Access Compliance Report

Public Rights-of-Way

Intersection ID: 27470	Main Street: FALLING_LEAVES_DR	Cross Street: WILLIAMS_POND_LN	Location: W
ADA ID: D39705F8F90E	Ramp Type: PerpDiag	Initial Pass/Fail: Fail	Overall Compliance: No
Severity Score: 12.5			
Codes/Mitigation Info/Possible Solution		Field Measurements/Component Compliance

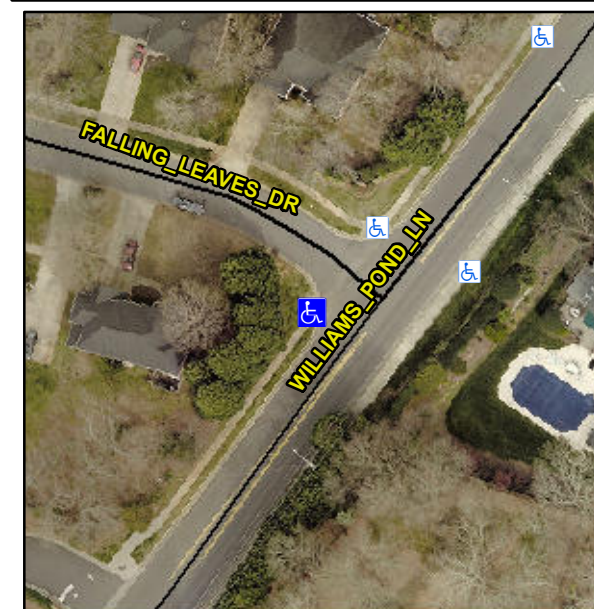
Not Found, R304.2.2

Compliance	Description	Data	Compliance	Description	Data
N/A	Ramp Length (in)	98.0	No	Ramp Slope (%)	9.1
Yes	Ramp Width (in)	48.0	Yes	Ramp XSlope (%)	0.1
N/A	Flare Type LT	N/A	N/A	Flare Type RT	N/A
N/A	Flare Slope LT (%)	N/A	N/A	Flare Slope RT (%)	N/A
N/A	Flare Traversable LT?	N/A	N/A	Flare Traversable RT?	N/A
N/A	Landing Length (in)	N/A	N/A	DWS Provided?	N/A
N/A	Landing Width (in)	N/A	N/A	DWS Contrast?	N/A
N/A	Landing Slope (%)	N/A	N/A	DWS Length (in)	N/A
N/A	Landing X Slope (%)	N/A	N/A	DWS Full Width?	N/A
N/A	Landing Curb? (Y/N)	N/A	N/A	DWS Offset (in)	N/A
N/A	Shared Landing?	N/A			
N/A	Gutter Ponding?	N/A	N/A	Gutter Slope (%)	N/A
N/A	Gutter Lip Ht (in)	N/A	N/A	Gutter X Slope (%)	N/A
N/A	Painted X Walk1?	No	N/A	Painted X Walk2?	No
	X Walk 1 Direction	To SE		X Walk 2 Direction	To NE
N/A	X Walk 1 Width (in)	N/A	N/A	X Walk 2 Width (in)	N/A
	X Walk 1 Slope (%)	3.8		X Walk 2 Slope (%)	0.1
	X Walk 1 X Slope (%)	0.4		X Walk 2 X Slope (%)	0.2

Remove & Replace Curb Ramp With Two New Directional Ramps or Equivalent.
